# Access Compliance Report

## Public Rights-of-Way

### (Curb Ramps)

Intersection ID: 5672	Main Street: SUNSET_RD	Cross Street: BEATTIES_FORD_RD	Location: SE
ADA ID: F54A9952E1AB	Ramp Type: Perp	Initial Pass/Fail: Fail	Overall Compliance: No
Severity Score: 13.75			
Codes/Mitigation Info/Possible Solution		Field Measurements/Component Compliance

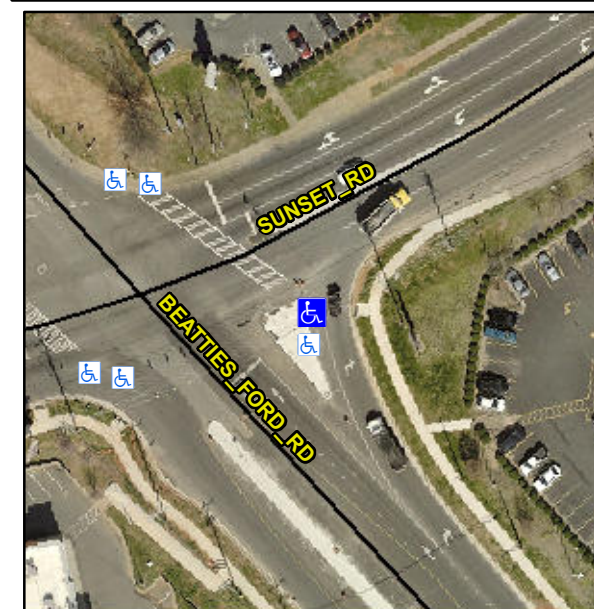
**Not Found, R304.2.2, R304.5.3**

Compliance	Description	Data	Compliance	Description	Data
N/A	Ramp Length (in)	60.0	No	Ramp Slope (%)	8.4
Yes	Ramp Width (in)	48.0	No	Ramp XSlope (%)	2.6
N/A	Flare Type LT	N/A	N/A	Flare Type RT	N/A
N/A	Flare Slope LT (%)	N/A	N/A	Flare Slope RT (%)	N/A
N/A	Flare Traversable LT?	N/A	N/A	Flare Traversable RT?	N/A
N/A	Landing Length (in)	N/A	N/A	DWS Provided?	N/A
N/A	Landing Width (in)	N/A	N/A	DWS Contrast?	N/A
N/A	Landing Slope (%)	N/A	N/A	DWS Length (in)	N/A
N/A	Landing X Slope (%)	N/A	N/A	DWS Full Width?	N/A
N/A	Landing Curb? (Y/N)	N/A	N/A	DWS Offset (in)	N/A
N/A	Shared Landing?	N/A			
N/A	Gutter Ponding?	N/A	N/A	Gutter Slope (%)	N/A
N/A	Gutter Lip Ht (in)	N/A	N/A	Gutter X Slope (%)	N/A
N/A	Painted X Walk1?	No	N/A	Painted X Walk2?	N/A
	X Walk 1 Direction	To NW		X Walk 2 Direction	N/A
N/A	X Walk 1 Width (in)	N/A	N/A	X Walk 2 Width (in)	N/A
	X Walk 1 Slope (%)	0.1		X Walk 2 Slope (%)	N/A
	X Walk 1 X Slope (%)	0.2		X Walk 2 X Slope (%)	N/A

**Remove & Replace Entire Ramp.**
